ADDENDUM NUMBER 3
for
ADVANCED TREATMENT PROJECT
FORT THOMAS TREATMENT PLANT
NORTHERN KENTUCKY WATER DISTRICT

FROM: CH2M HILL
TO: Plan Holders of Record

PROCESS MECHANICAL
SAMPLING PUMP DETAILS

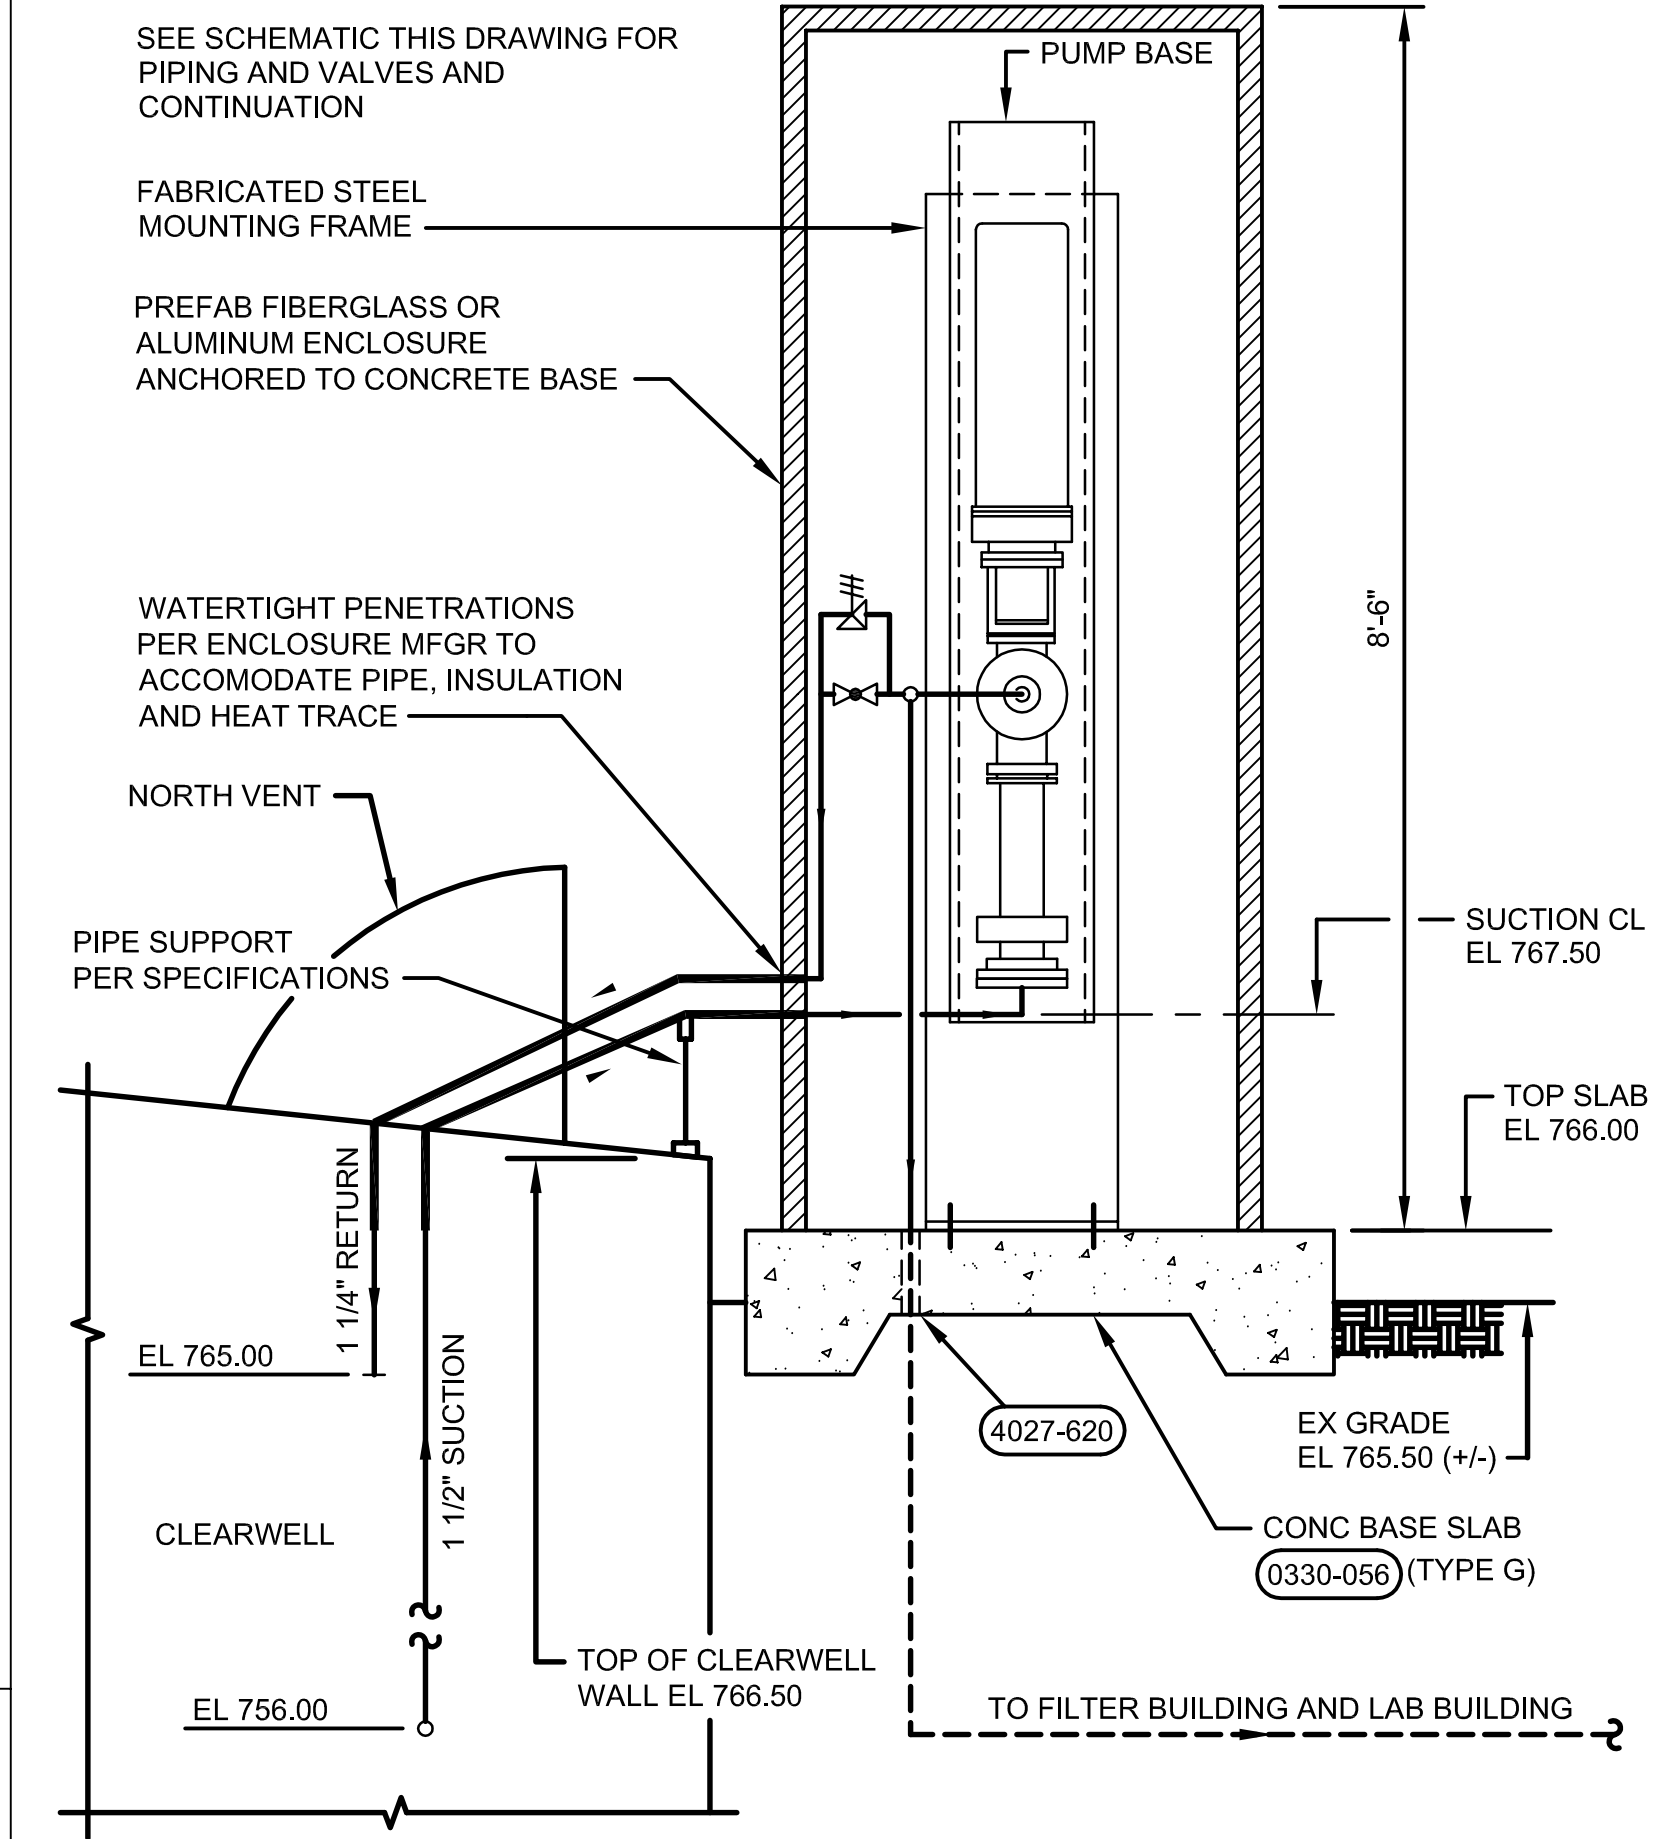
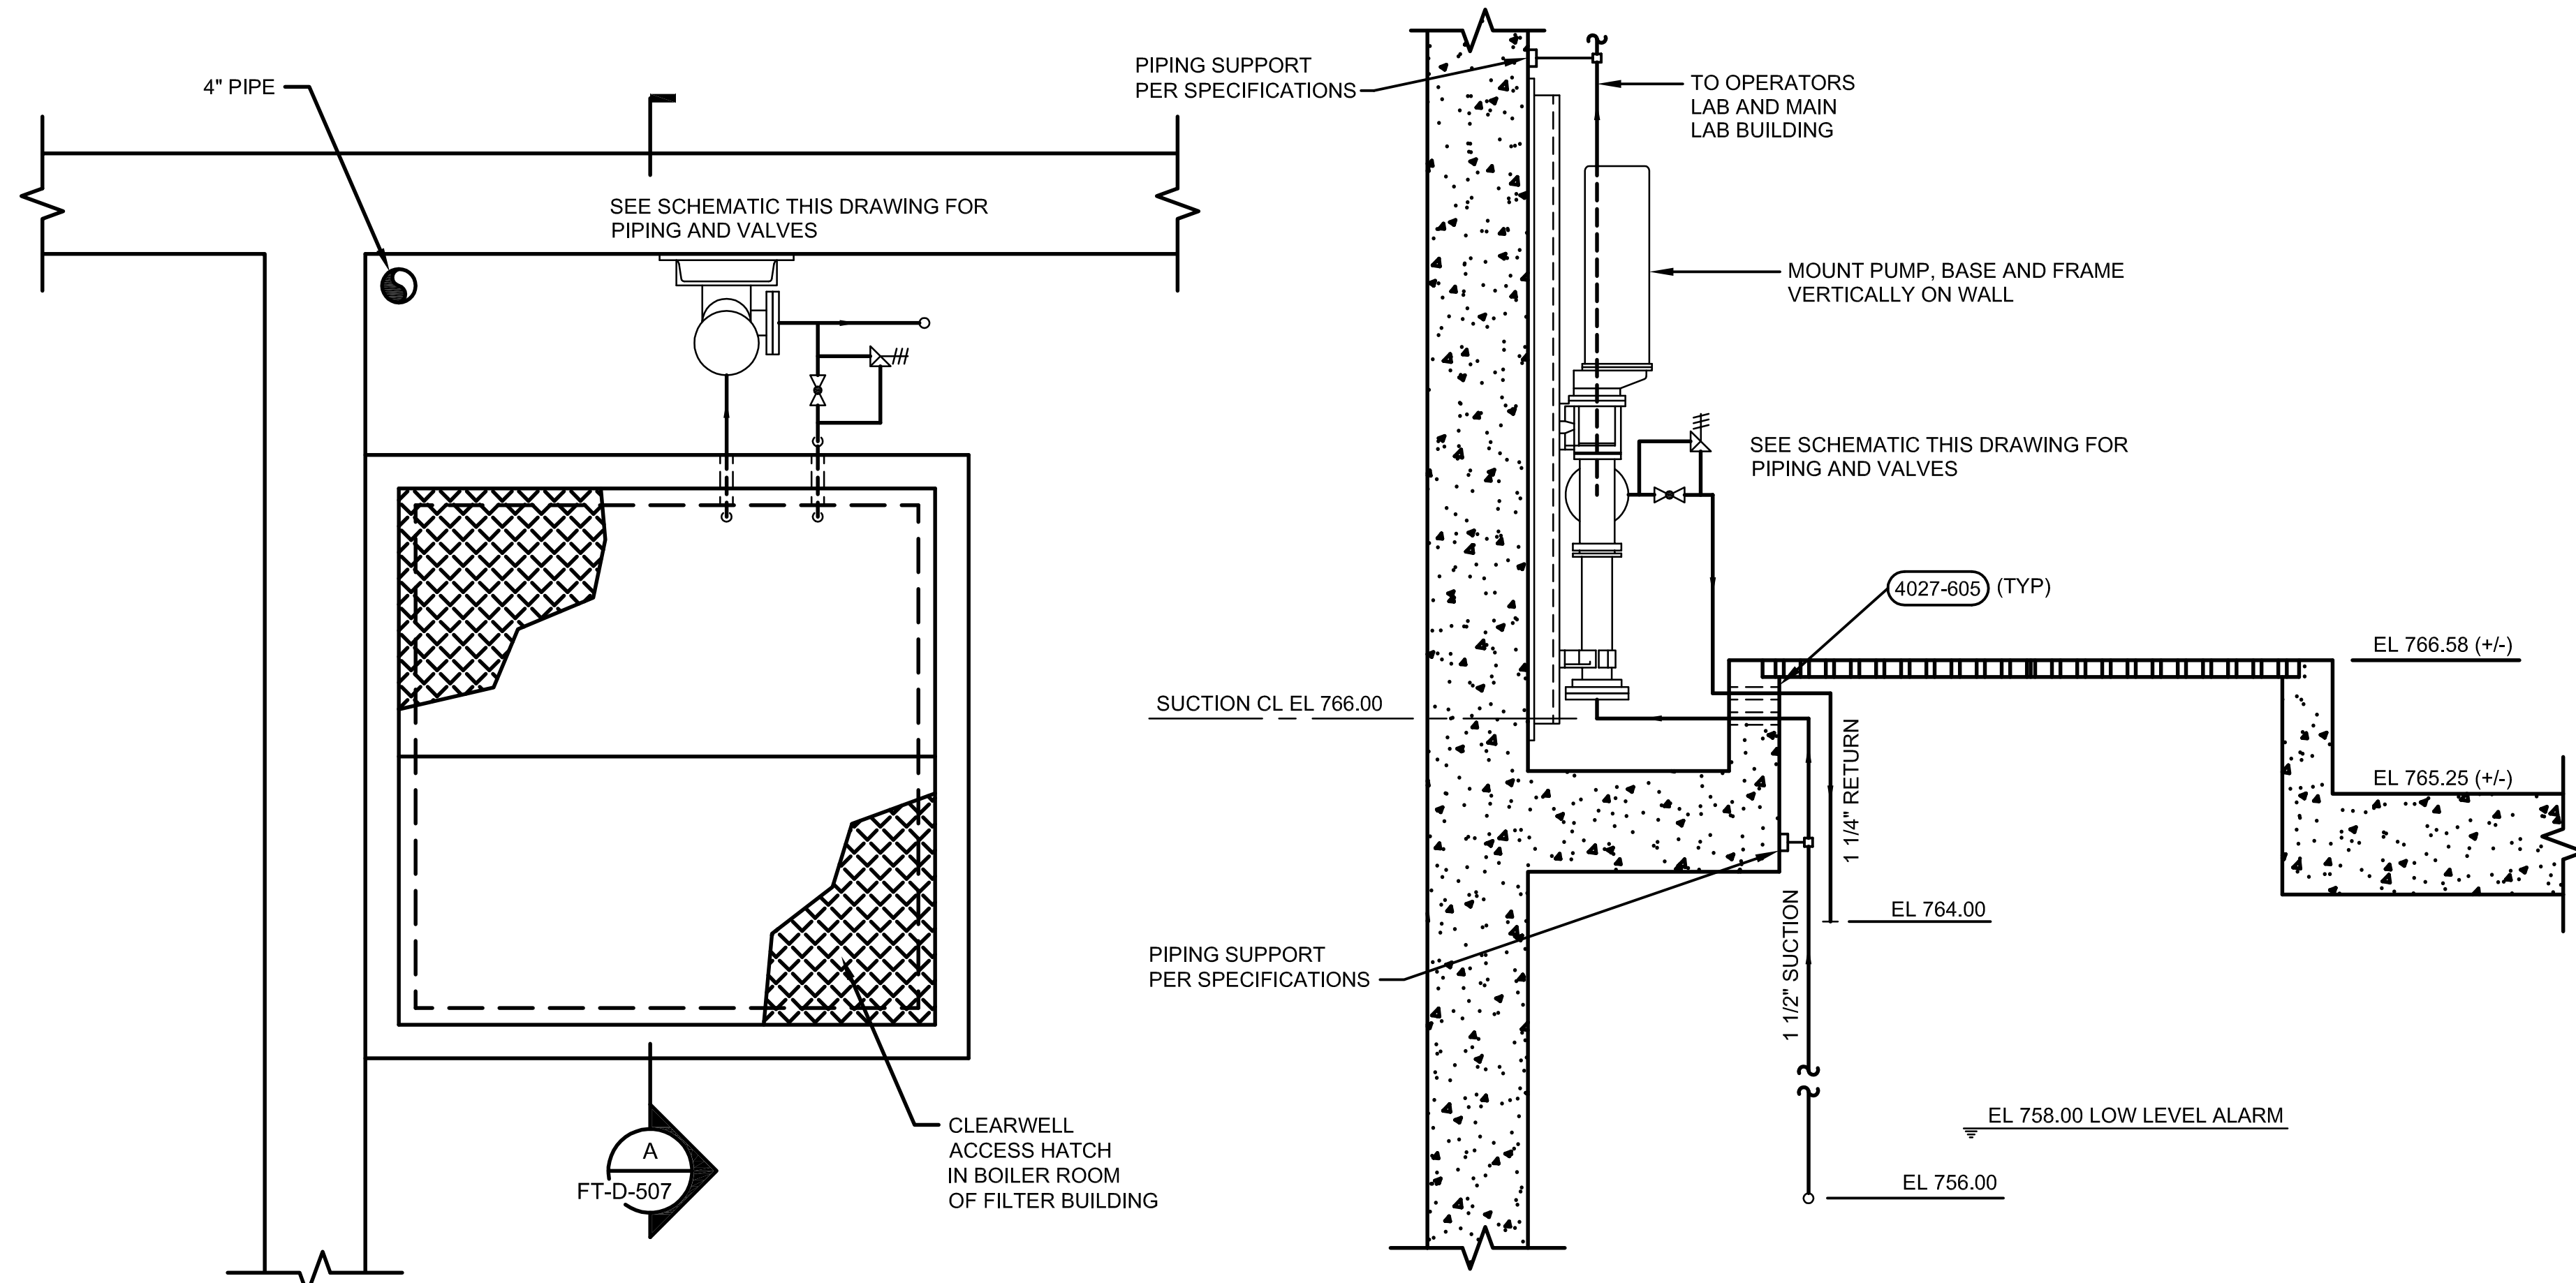
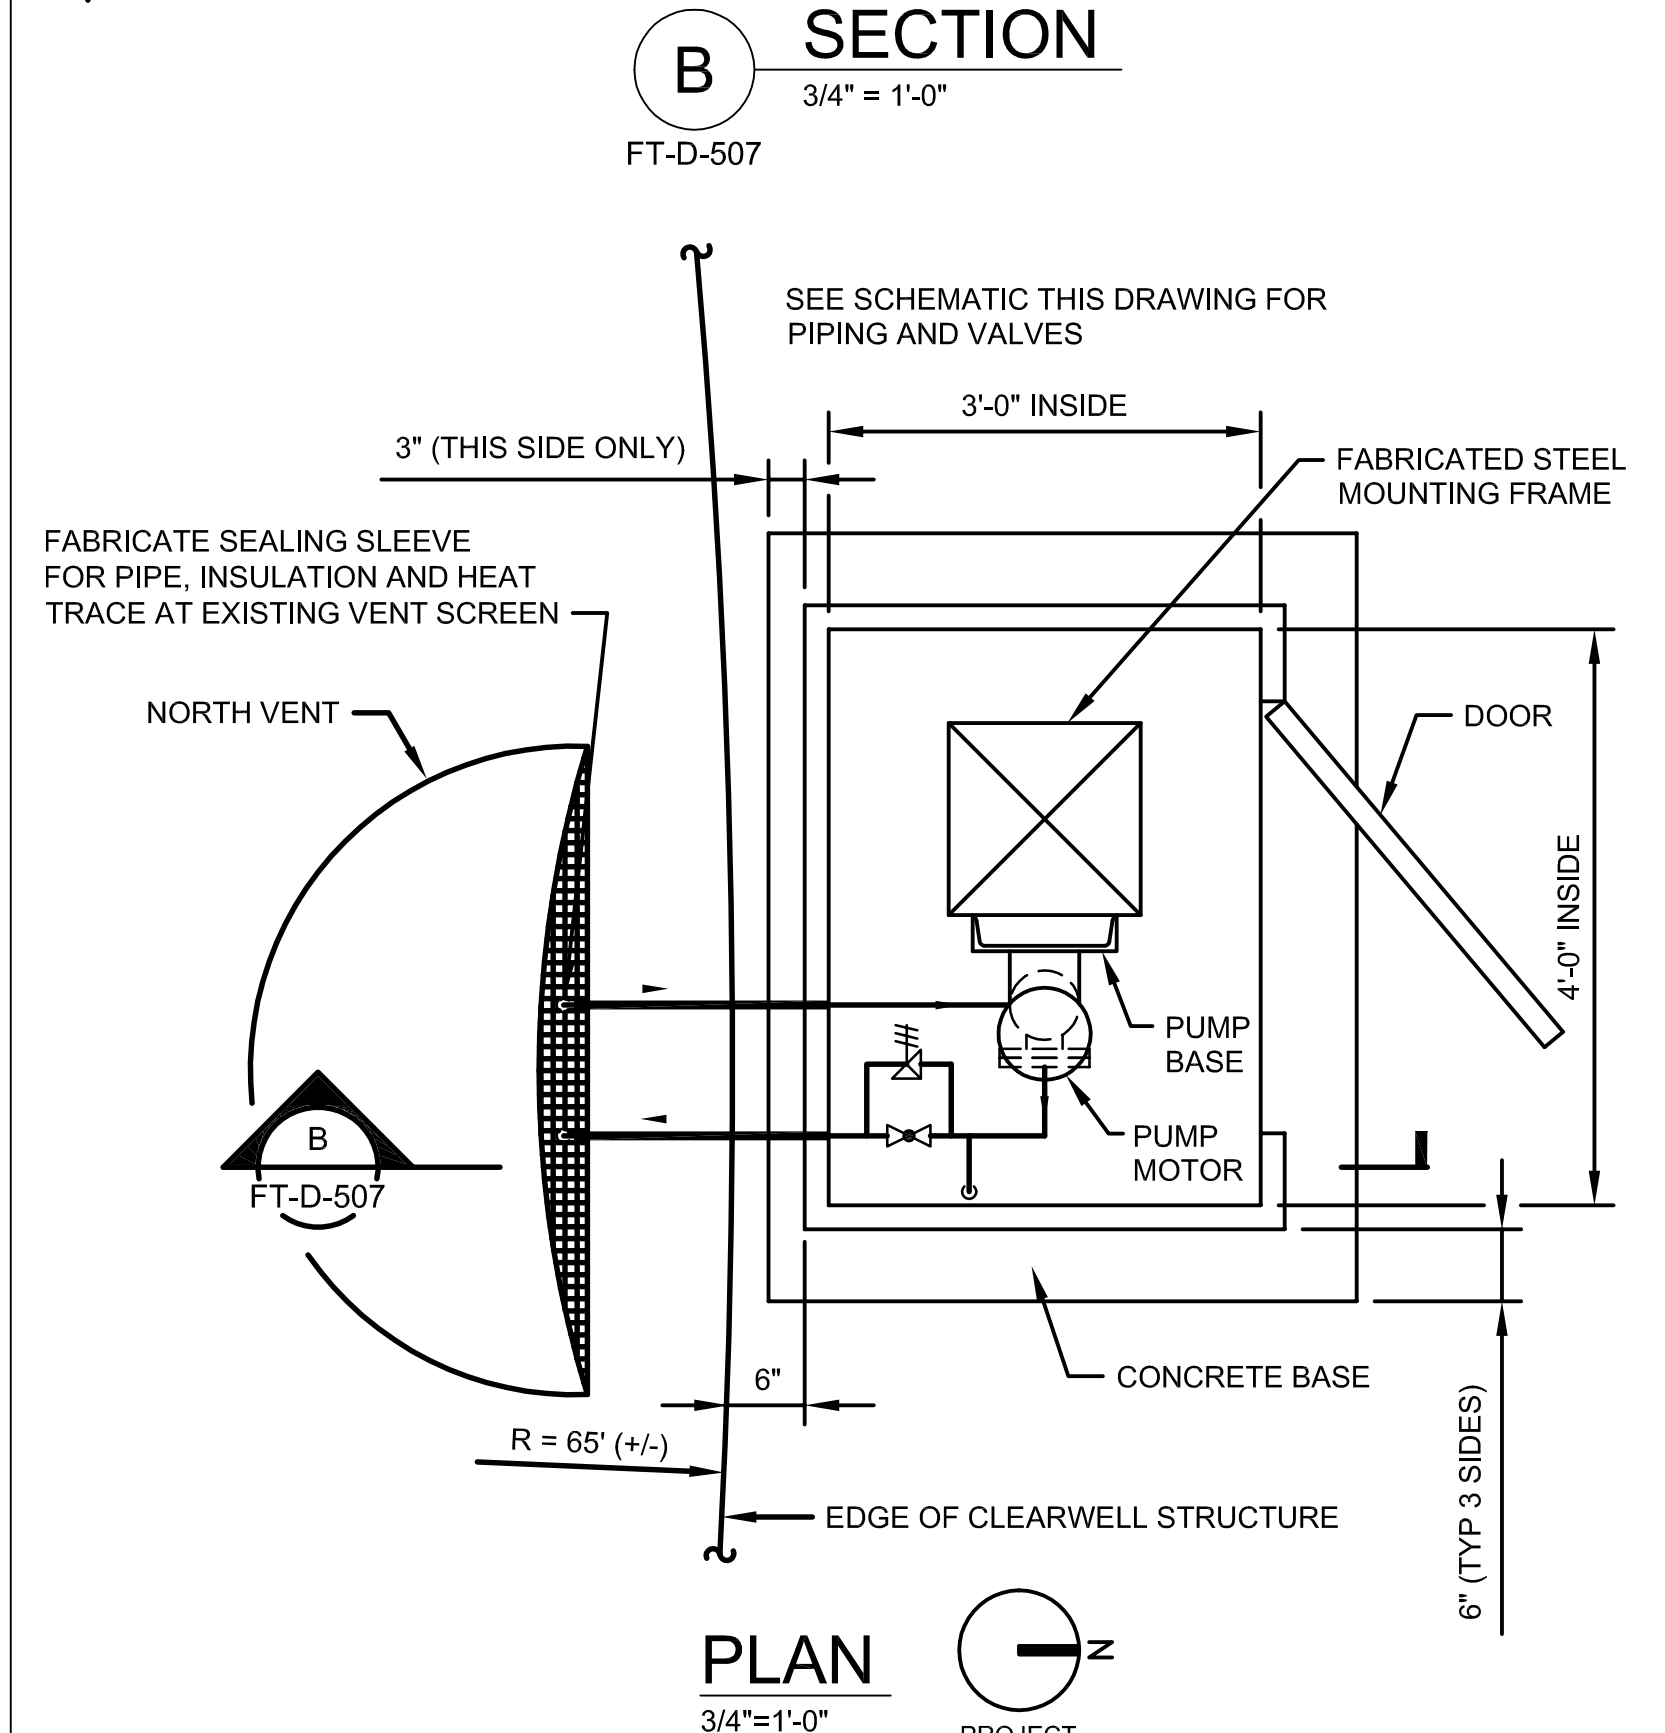
Drawing “FT-D-507 SAMPLING PUMP DETAILS” is attached to this addendum and shall be incorporated into the bid documents and contract drawings.

The enclosure for FWSP-002 referenced by Keyed Note 19 on this drawing is shown at the east vent of clearwell no. 2. Revise the location of this enclosure by moving it counterclockwise 90 degrees so it is adjacent to the north vent of clearwell no. 2. Refer to drawing FT-D-507.
